SAB-EEC-88-029

REVIEW OF THE
UNDERGROUND STORAGE TANK (UST)
RELEASE SIMULATION MODEL

ENVIRONMENTAL ENGINEERING COMMITTEE
SCIENCE ADVISORY BOARD
U.S. ENVIRONMENTAL PROTECTION AGENCY

Rough Calculation of UST Leak Volatilization

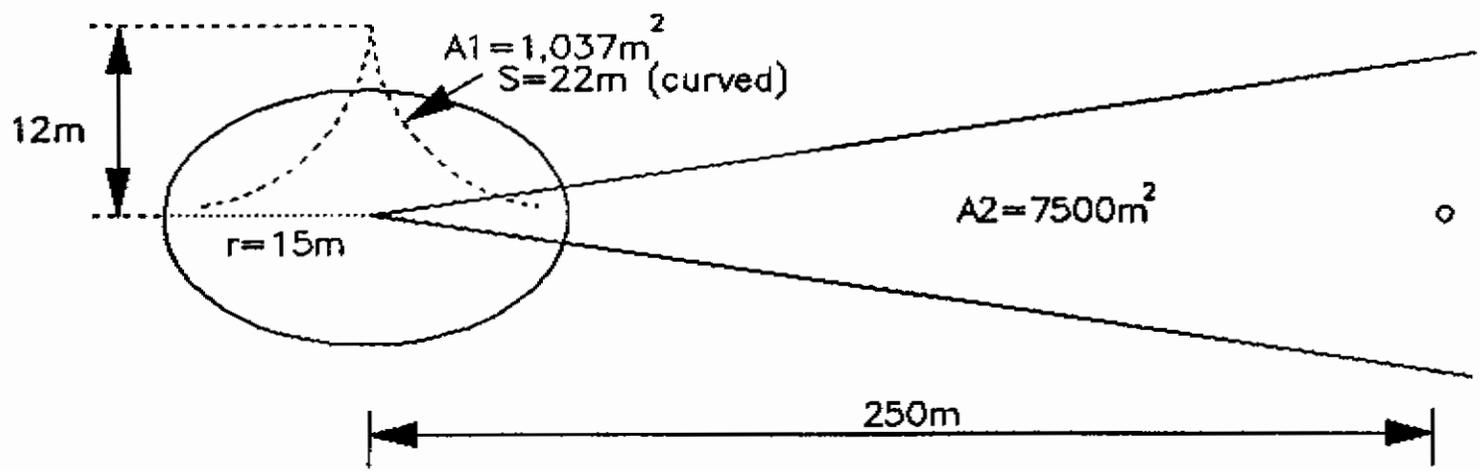
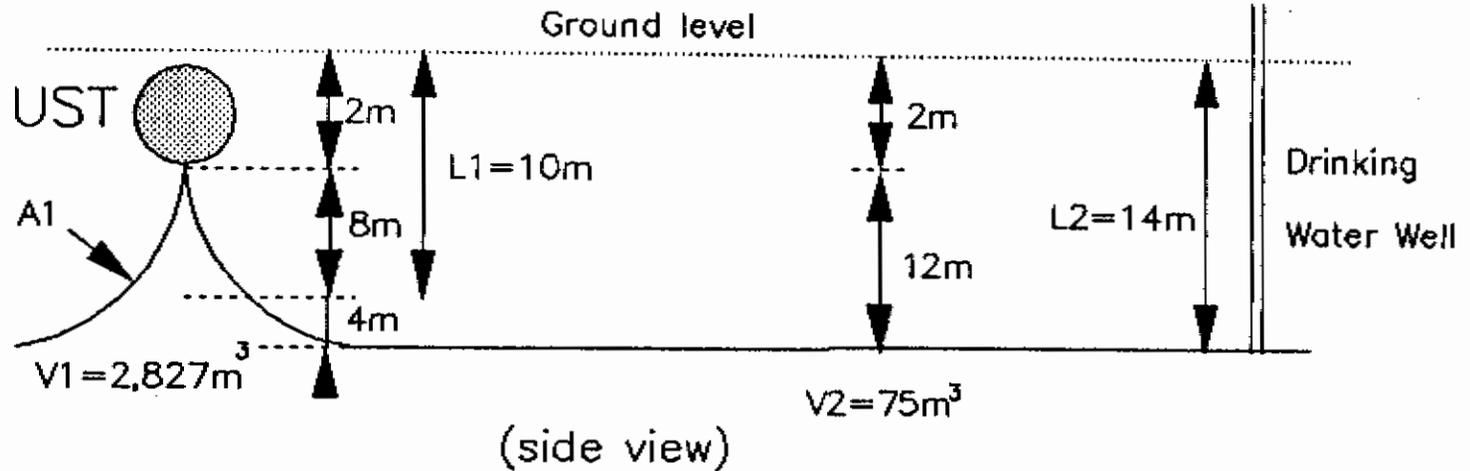
2. The air pathway is inadequately considered. Volatilization of constituents, including benzene, may well affect UST releases (see Appendix C). Spills may volatilize before they infiltrate to ground water. Constituents may also volatilize from the unsaturated and saturated zone plumes. Not only will this mechanism affect ground water releases, but it also creates a new pathway for risks. Unless a rationale exists for discounting volatilization, such releases and their movement should be considered.
